From Coal-Equivalent Plants to a Coal-Equivalent Fleet: Plant-Level Evidence for Firm Solar in India

March 2026

Review markup (24 Jul 2026): text in green is proposed for deletion or relocation, pending author approval. Where a green value or sentence is immediately followed by a red one, the red text is the proposed correction. Text newly added in this pass is red.

Figure 3: Monthly hourly availability panel

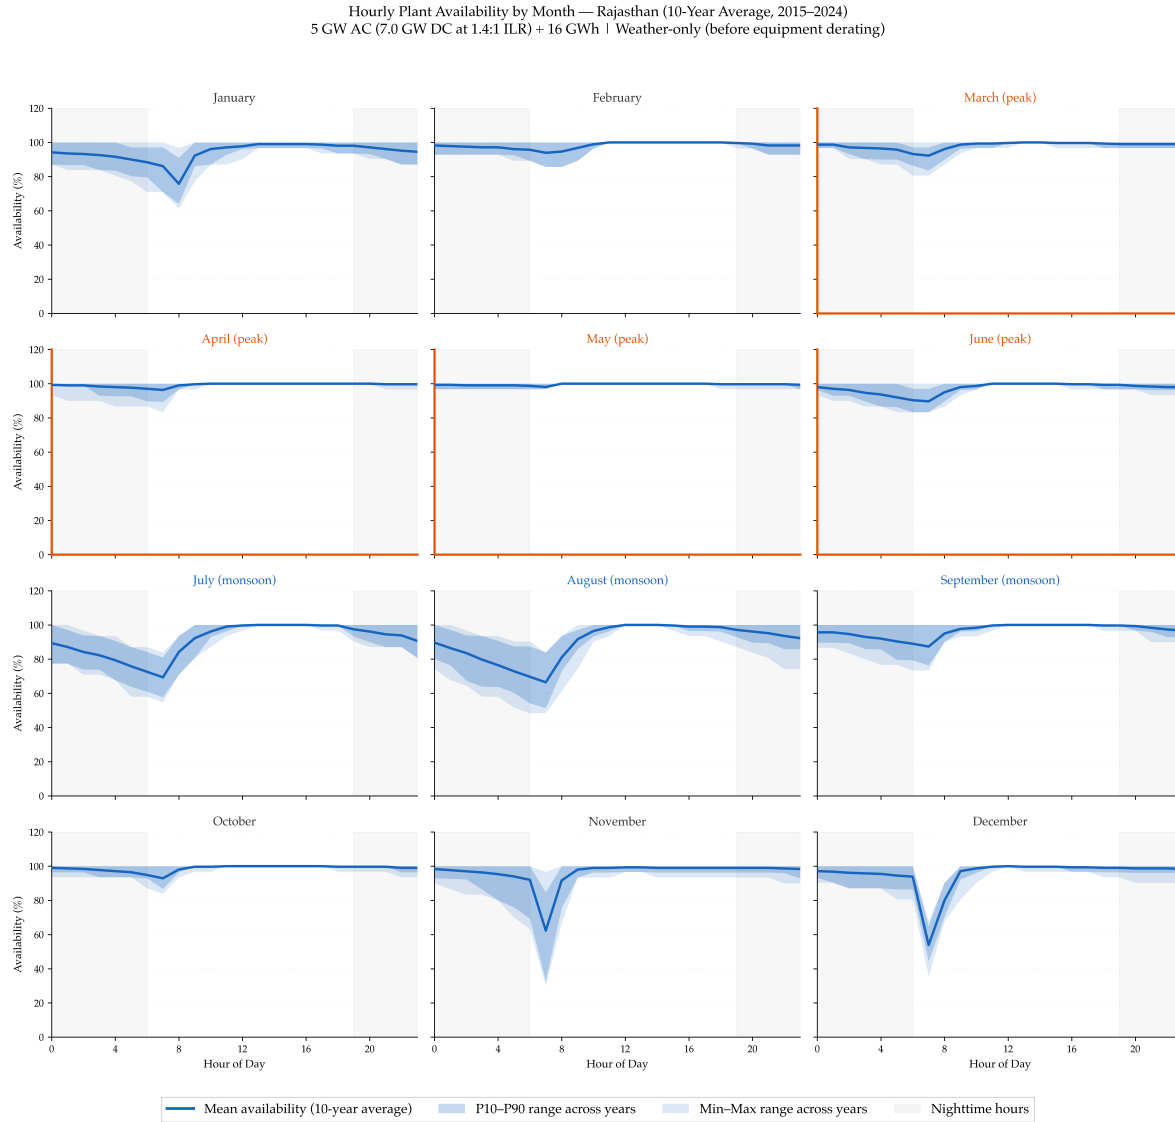
[Proposed move to Appendix B: Figure 3 and the four paragraphs below. The battery-carries-the-night point is already made by Figures 1, 2, and 4.]

Figure 7: Availability vs normalized demand

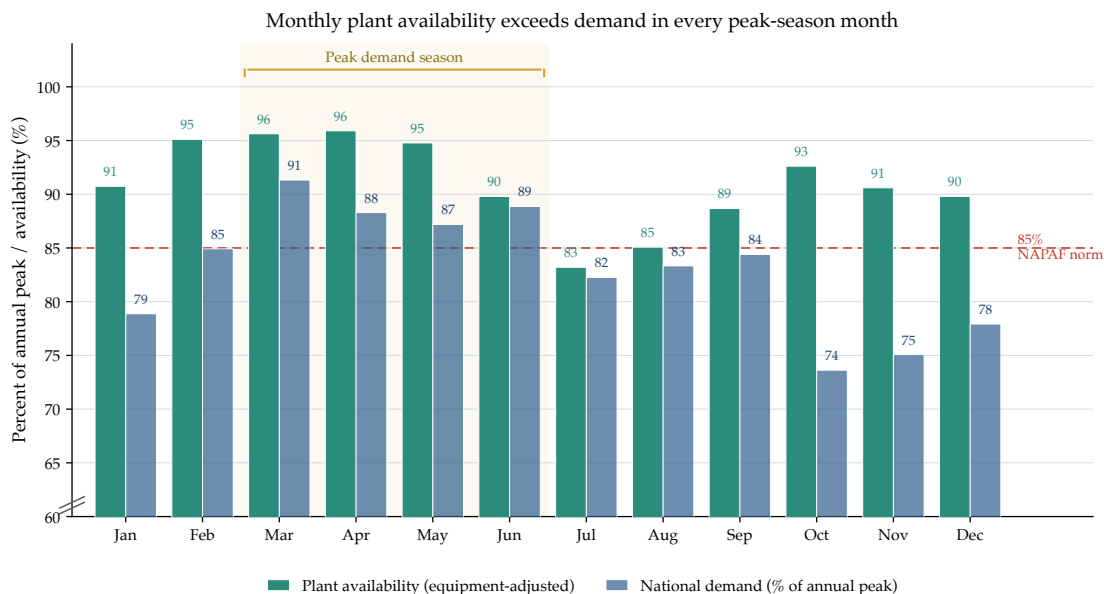
[Proposed cut: Figure 7 and the paragraph below repeat Figure 4’s availability-tracks-demand message; keep Figure 4.]
